ADDENDUM NO. 2

TO: All Holders of Plans and Contract Documents for
 TAP-1601(706) – Airport Drive and Fairview Avenue
 Jasper County, Carthage, Missouri

ISSUED: May 1, 2025

C-1.0
COVER SHEET

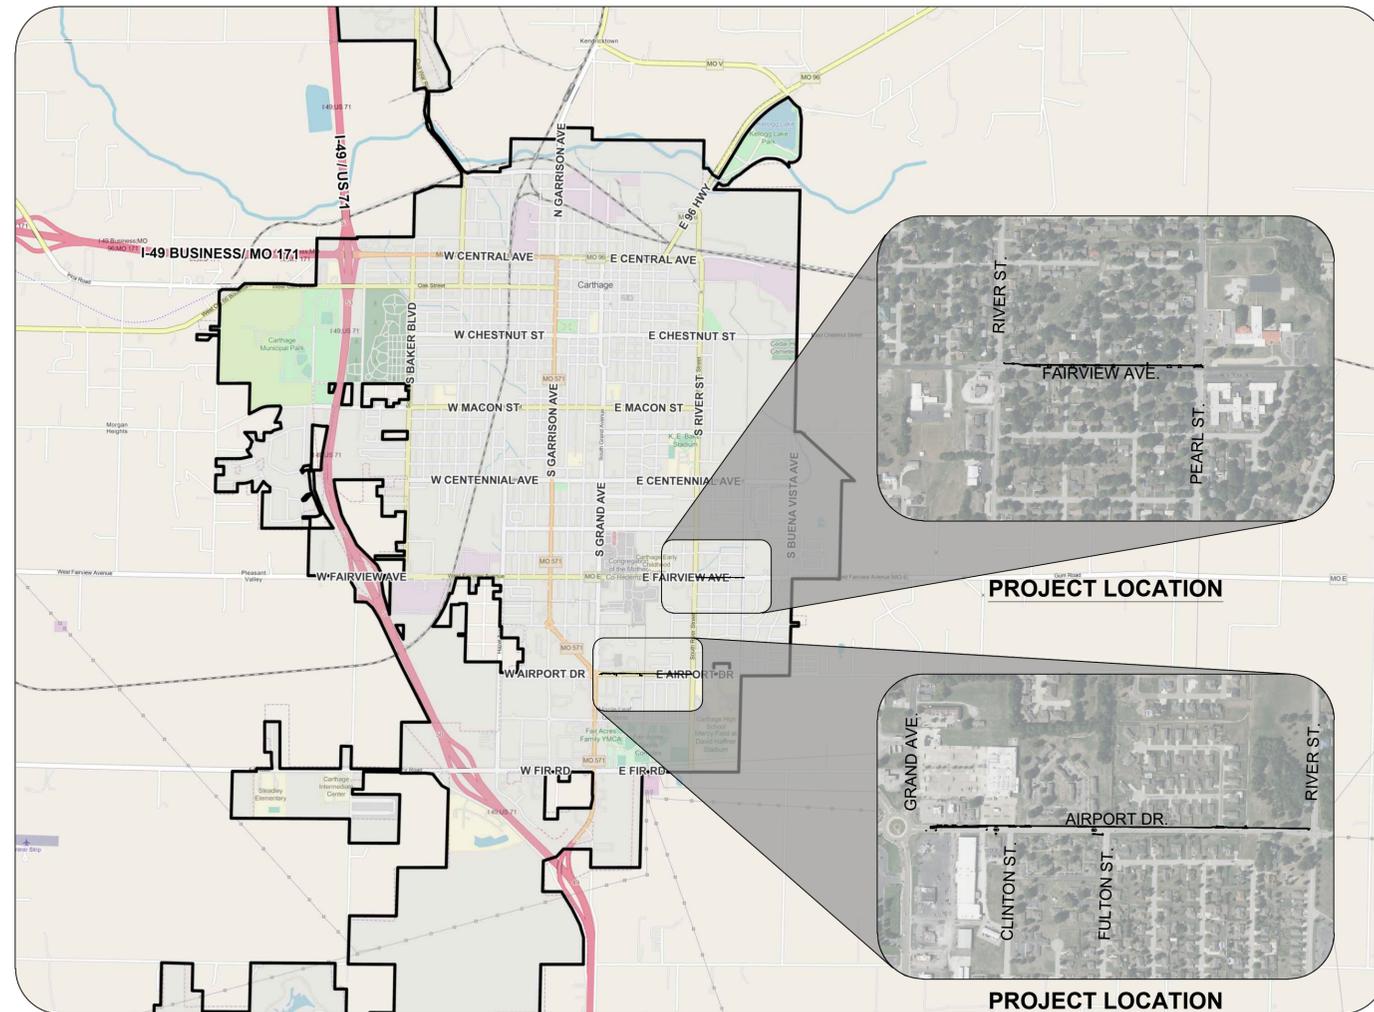
- 1) The attached Bid Proposal Form is hereby revised and shall be used for bid submission. The following changes are as follows:
 - a) Relocate Power Pole has been deleted. CWEP will install the power pole as shown on the plans.
 - b) Relocate Fire Hydrant has been revised to show 5 LF of D.I.P. to be included.
- 2) **NOTE:** The revised DBE forms attached to Addendum #1 shall be used for bid submission. The DBE goal is set at 0%.

- 1) The attached Plan Sheets C-1.0 and C-1.1 are hereby revised and shall be used for bid submission.
